**SUBJECT:** **CHANGE ORDER #2 TO MATRIX HG INC. FOR THE  
FAIRFIELD CAMPUS CENTRAL PLANT REPLACEMENT  
PROJECT**

**Change Order #** 002  
**Project No.:** 23-005  
**Date:** 7/17/2024

**Project:** Solano Community College District  
Fairfield Campus  
**CENTRAL PLANT REPLACEMENT PROJECT**

Solano Community College Central Plant Modernization  
Matrix Job #230477  
**CHANGE ORDER PROPOSAL SUMMARY SHEET**

**S-5.3**

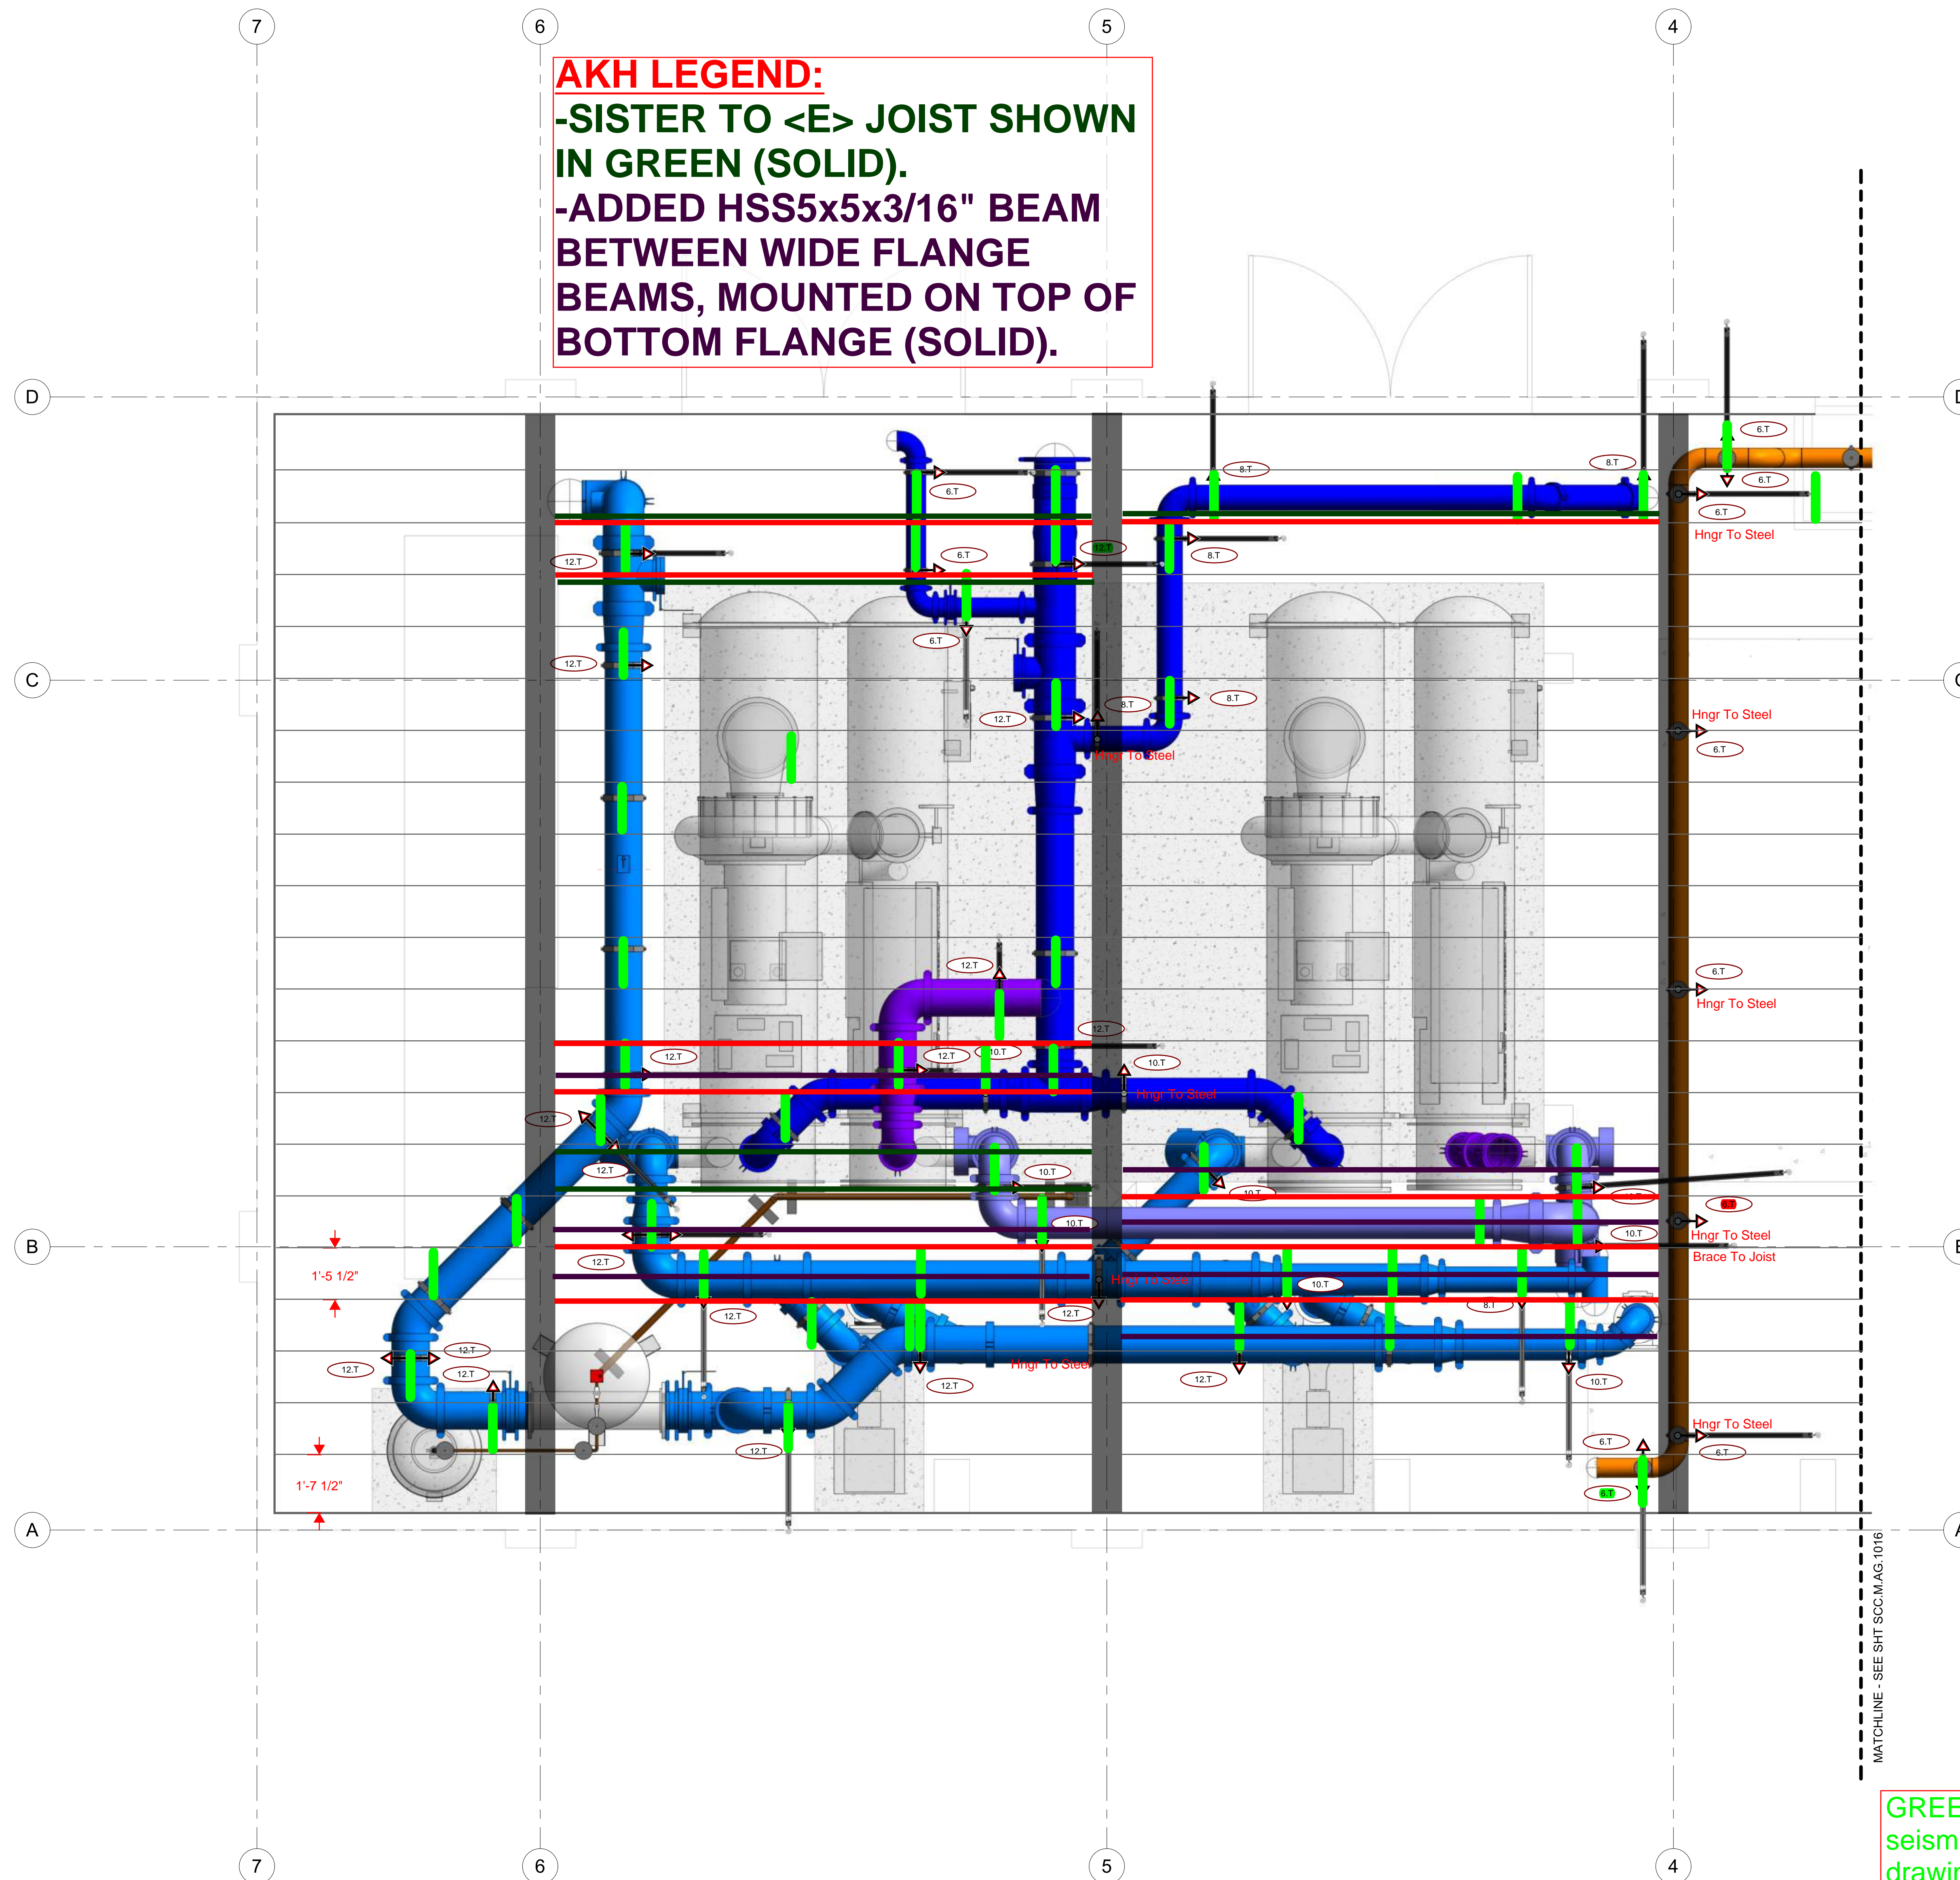
Request: We see conflicts between the piping layout and noted requirements in the structural attachment details which has been compounded by the seismic drawing review comments which said: "Added requirement: Hanger rods per 1 & 2/S5.3 shall occur within the middle one-half of block length. Hanger rods can be sloped up to 1/2H:12V as reqd."

Detail 1/S-5.3 says that "No existing single 2X12 joist shall receive more than (3) blocks w/ Hanger rods over span length of joist, from one side, or from both sides combined."

Q: Per the notes in detail 1/S-5.3 we need the SEOR to review these conditions and advise if they are acceptable or advise changes as required.

Q1: Yes, partially, only in-between wood joists. As stated in the shop drawings, refer to details 1, 2 & 10/S5.3 of the DSA approved set of drawings, for hanger rod requirements to wood framing and with the added requirements noted in the shop drawings such as of hanger rods can only occur within the middle one-half of the blocking. Hanger rods can be sloped up to 1/2H:12V as required to reach block, etc. Additionally, for lateral braces to wood framing, refer to details 6/ 7 & 9/S5.3 of the approved DSA set of drawings. Lastly, see following pages SBSCC.M.AG.1015 & SBSCC.M.AG.1016 for locations of proposed added joists, sistered to existing wood joists, and/or addition of new HSS beams atop bottom flanges of existing transverse beams.

Q4: If a single joist will receive more than (3) blocks attached to it, over the entire span length of the joist, from one side, or from both sides combined, the existing joist can be strengthened with a new 2x12 sister (depending on the pipe load), similar to detail 24/S5.1 of the approved set of drawings and or new HSS beams are being added. Refer to following pages SBSCC.M.AG.1015 & SBSCC.M.AG.1016 with locations of proposed sistered joists to existing wood joists.

**SBSCC.M.AG.1016**

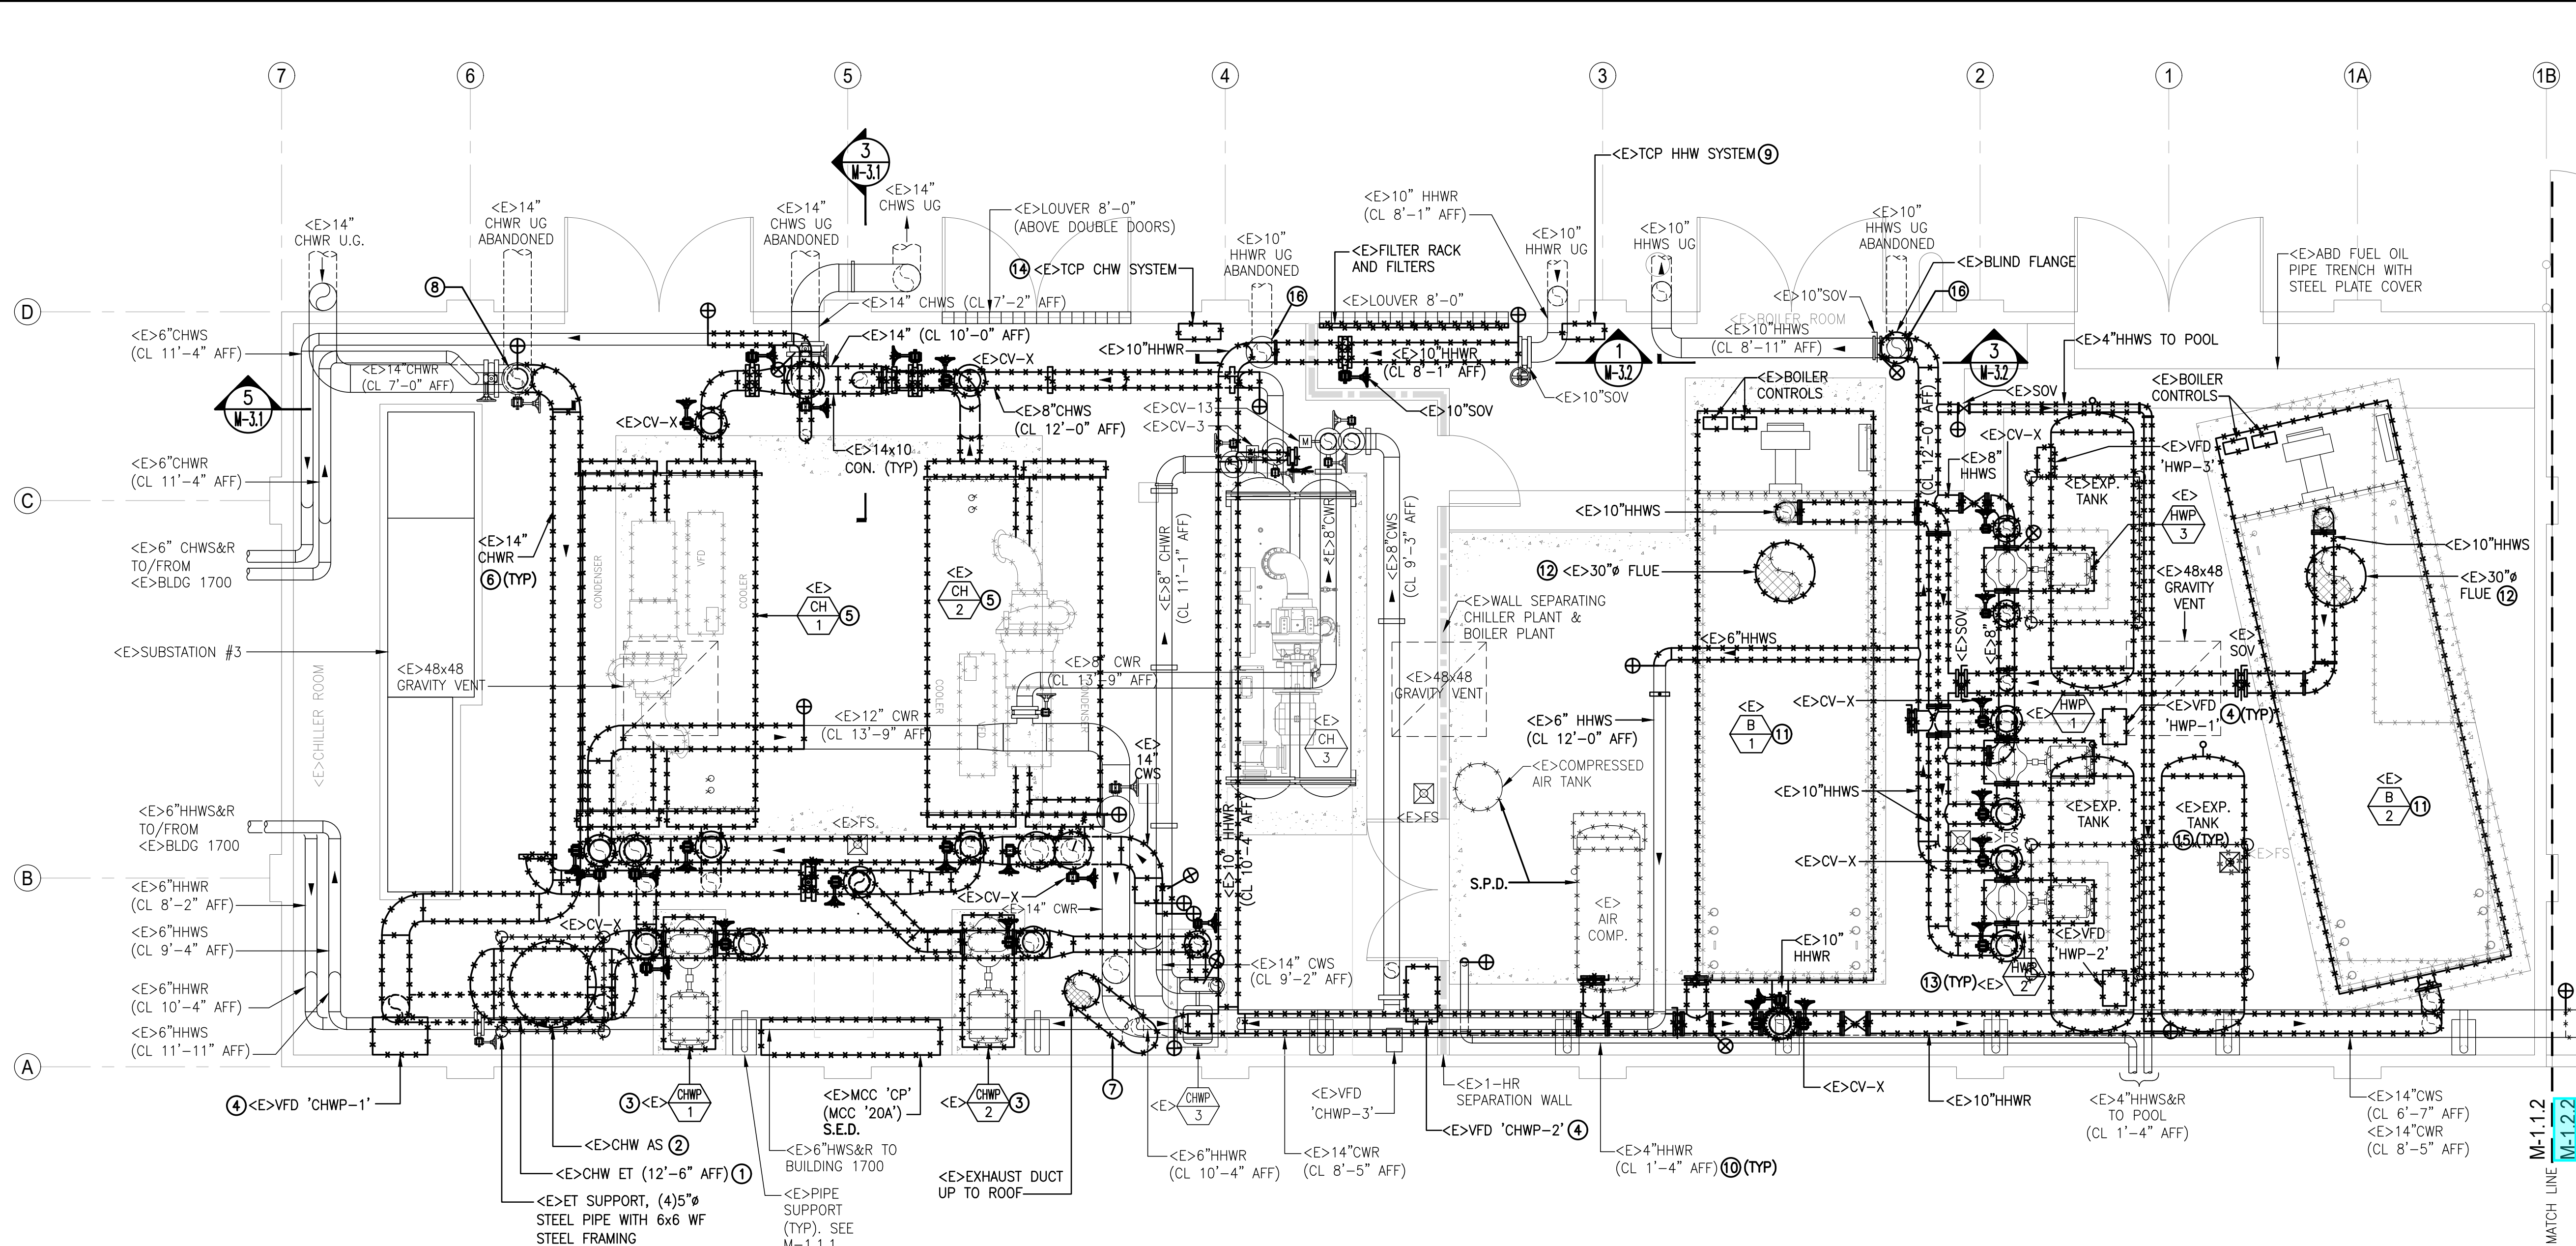
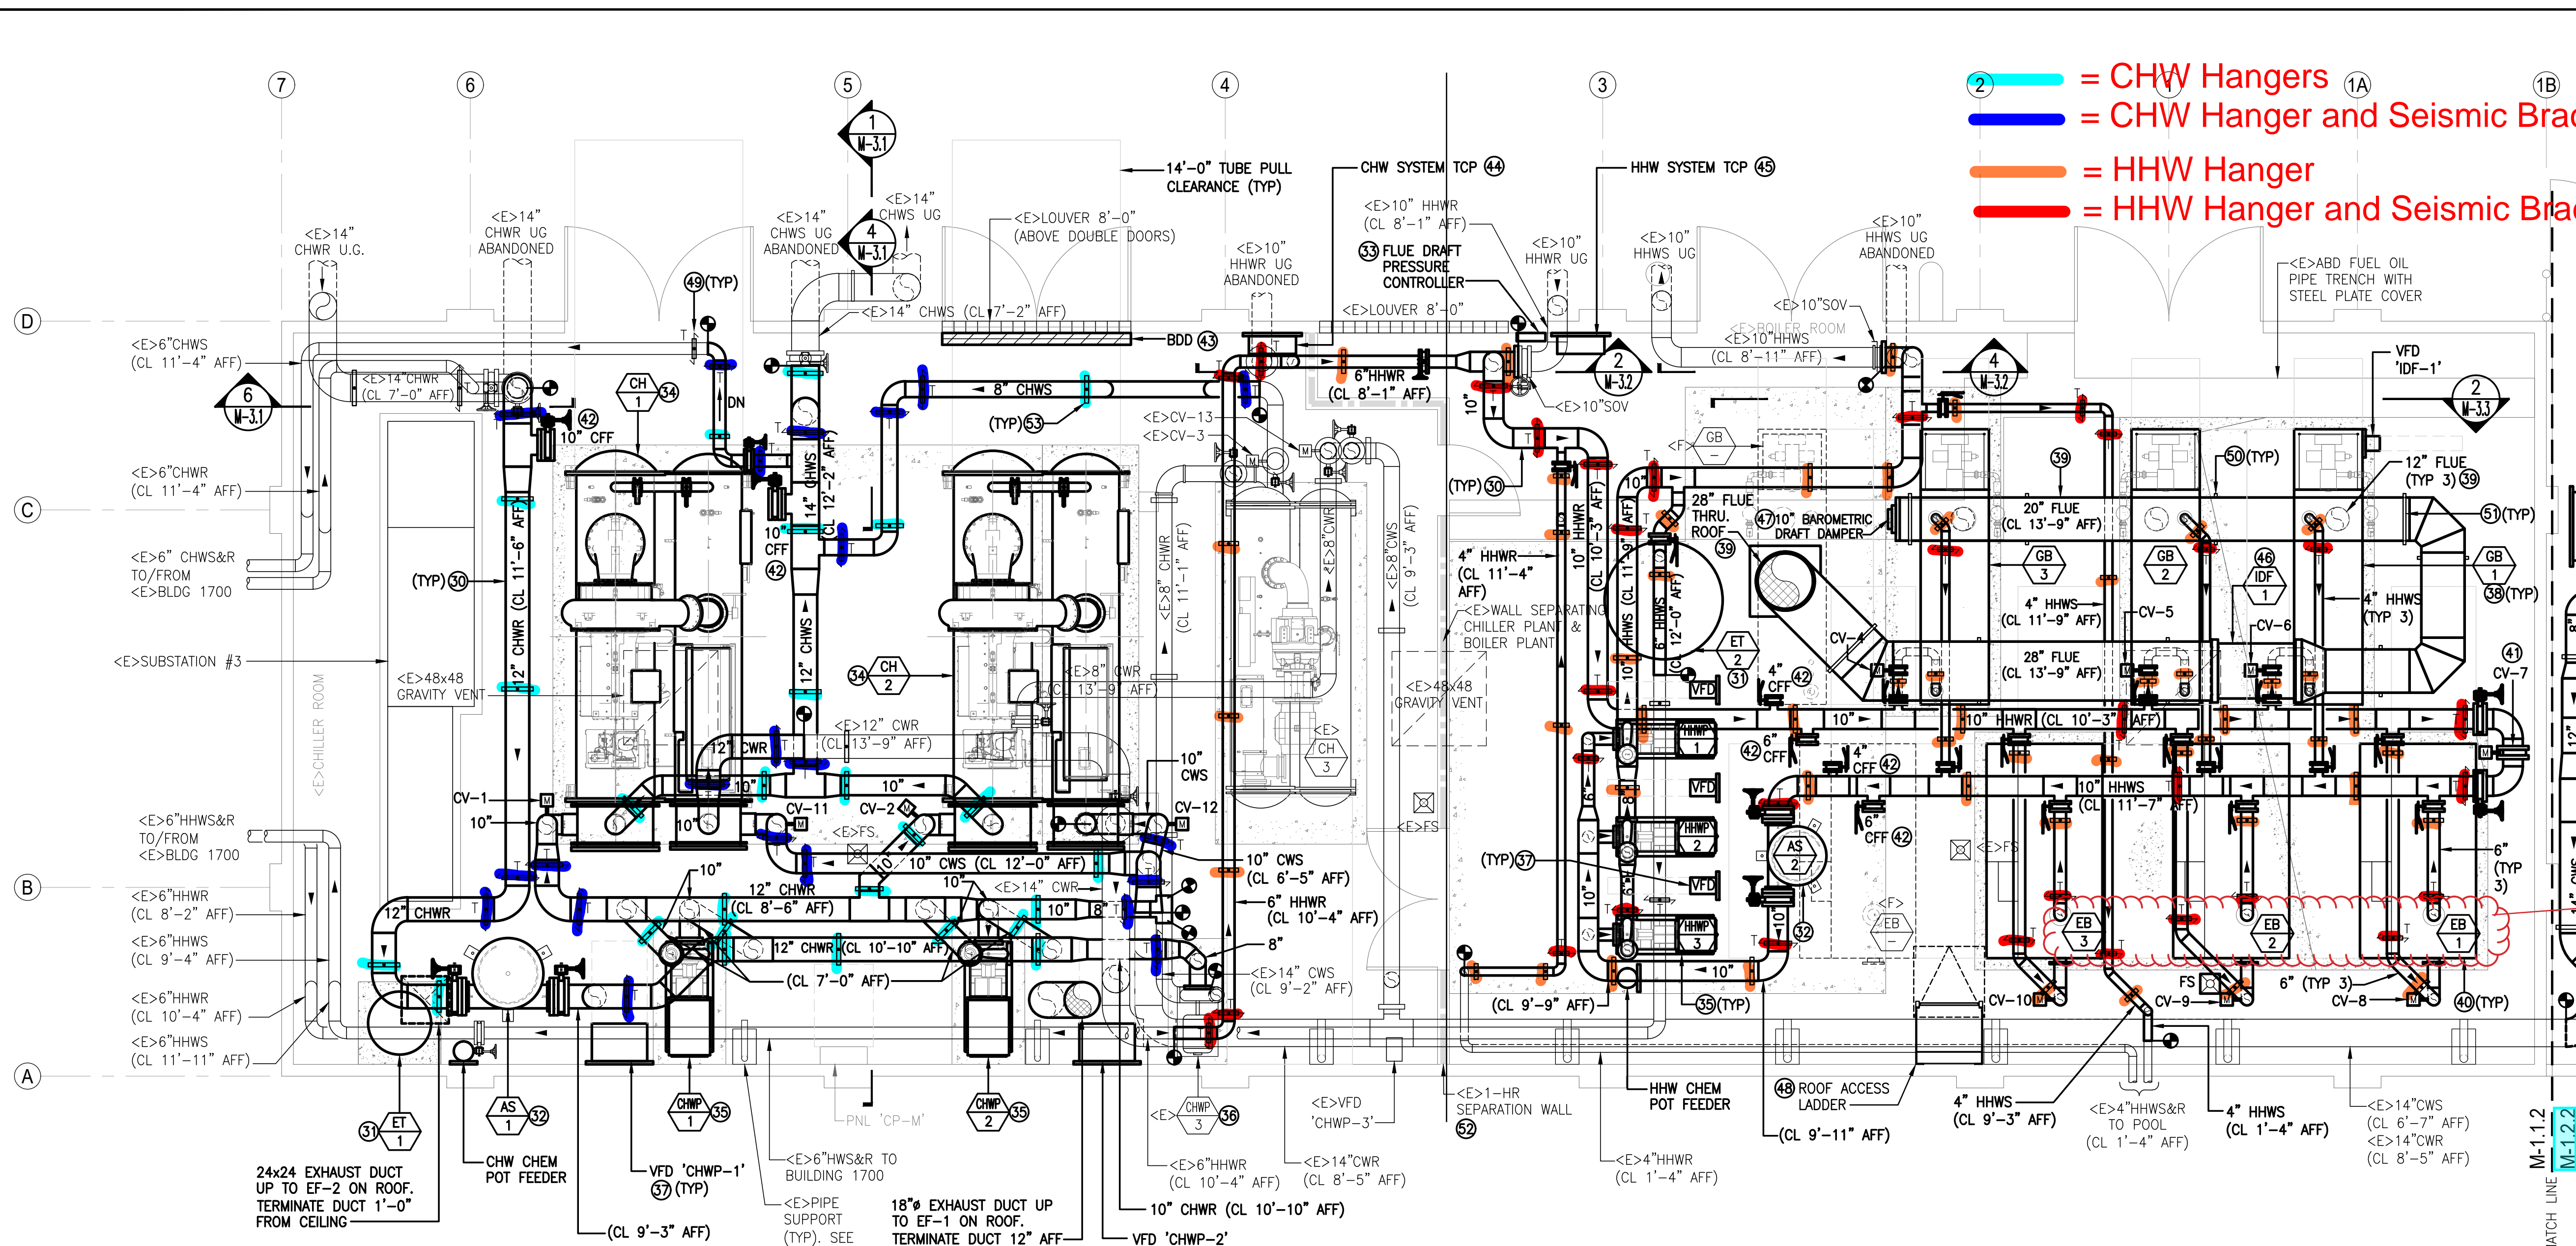
- SISTER TO <E> JOIST SHOWN IN GREEN (SOLID).
- ADDED HSS5x5x3/16" BEAM BETWEEN WIDE FLANGE BEAMS, MOUNTED ON TOP OF BOTTOM FLANGE (SOLID).

GREEN - Indicates hanger or seismic brace per contract drawings  
RED - Indicates overloaded joist

GREEN - Indicates blocking for piping hanger  
BLUE - Indicates blocking for flue hanger  
RED - Indicates overloaded joist
